Thank you for agreeing to accept additional comments from me on the St Leonards South Proposal.

### **Overshadowing of Public Open Spaces**

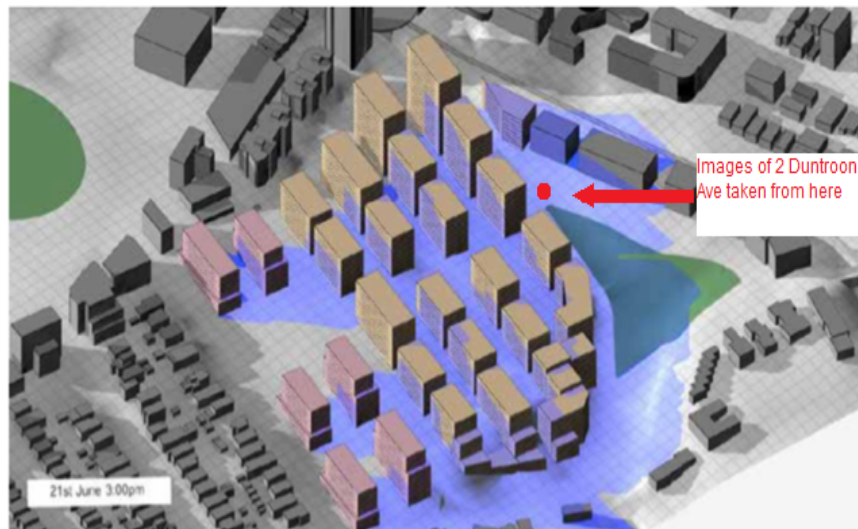
For **Residential areas outside the boundary**, there must be no overshadowing from new development for the whole time between **9.00 am and 3.00 pm**. The discussion in the interview with Lane Cove Council about the accuracy, or otherwise, of the Department of Planning's shadow diagrams has already been mentioned (please refer to P-33 to P-36 of the transcript). Council staff appear to suggest that while the Department's shadow diagrams showed overshadowing of the low rise residential area on River road, Council's own shadow diagrams did not show any overshadowing between 9.00 am and 3.00 pm along River Road. I would expect that the Department of Planning would have the resources to provide some input as to the accuracy of the Shadow Diagrams, and I will make no further comment on this.

But, there is also the requirement that new development does not produce any additional overshadowing to **Residential areas inside the boundary** and that these residential areas **must maintain solar access for at least three hours between 9.00 am and 3.00 pm**. Upon examining the Department of Planning's Shadow diagrams, it is clear that 2 Canberra Avenue (the triangular site immediately north of 2 Duntroon which is currently under construction – 6 storeys), 2 Duntroon Avenue (5 storeys), and parts of 4 Duntroon Avenue (7 storeys), will not receive the required three hours of sunlight in mid-winter. To understand this, it is necessary to use the Department of Planning's Shadow diagrams, since they are displayed in half hour intervals – those of Lane Cove council are shown in their presentation to you only in 1.5 hour intervals.

And on Page 84, the following Shadow Diagram is accompanied by the statement that **“2 hours solar access is generally problematic to 70% of units on 21<sup>st</sup> June (midwinter)”**.

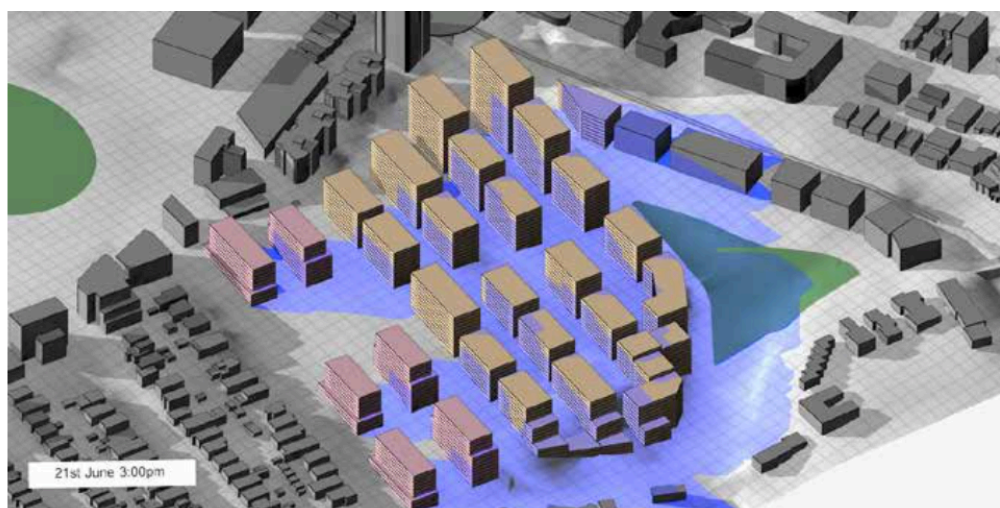
2 hours solar access is generally problematic to 70% of units on 21st June (midwinter).

Had the Draft Plan intended the solar amenity guidelines to be tested in May or July, it is assumed it would have stated as such. In any event, Attachment M seems to be using a solar amenity standard of 2 hours. This is not the Design Criterion contained in the Draft Plan. The Draft Plan unequivocally states, on Page 26, that **solar access is required for at least 3 hours for residential**

It is clear, as for the residences at 2 Canberra Avenue, 2 and 4 Duntroon Avenue, that for 70% of the residences in the SLS proposal area, this standard will not be achieved with the Plan with the heights currently proposed.
